## Product / Process Change Notification (PCN)

<p><b>PCN #:</b> PCN_UtMID_20230208</p> <p><b>Affected Series:</b> See affected p/n's below</p> <p><b>PCN Date:</b> November 08, 2022</p> <p><b>Effective Date:</b> February 08, 2023</p> <p><b>Effected Date Code:</b> Week 6 of Year 2023</p> <p><b>Revision:</b> See below</p>	<p><b>Change Category:</b></p> <p><input type="checkbox"/> Equipment / Location</p> <p><input checked="" type="checkbox"/> General Data</p> <p><input checked="" type="checkbox"/> Material</p> <p><input type="checkbox"/> Process</p> <p><input type="checkbox"/> Product Design</p> <p><input type="checkbox"/> Shipping / Packaging</p> <p><input type="checkbox"/> Supplier</p> <p><input type="checkbox"/> Software</p>
<p><b>Contact:</b> Design Engineering PCN Specialist</p> <p><b>Phone:</b> +1 (605) 886 1427</p> <p><b>Fax:</b> +1 (605) 886 4486</p> <p><b>E-Mail:</b> pcn.midcom@we-online.com</p>	<p><b>Data Sheet Change:</b></p> <p><input checked="" type="checkbox"/> Yes      <input type="checkbox"/> No</p> <p><b>Attachment:</b></p> <p><input type="checkbox"/> Yes      <input checked="" type="checkbox"/> No</p>

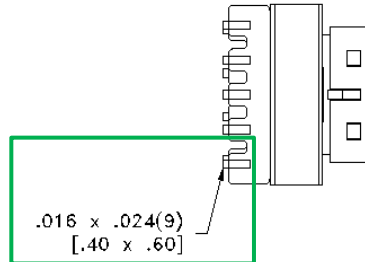
Additionally, in line with internal standardization, Würth Electronics Midcom will add the bare terminal dimension to the specification sheet. There will be no change to footprint.

Bare terminal dimension will be added to the specification sheet:
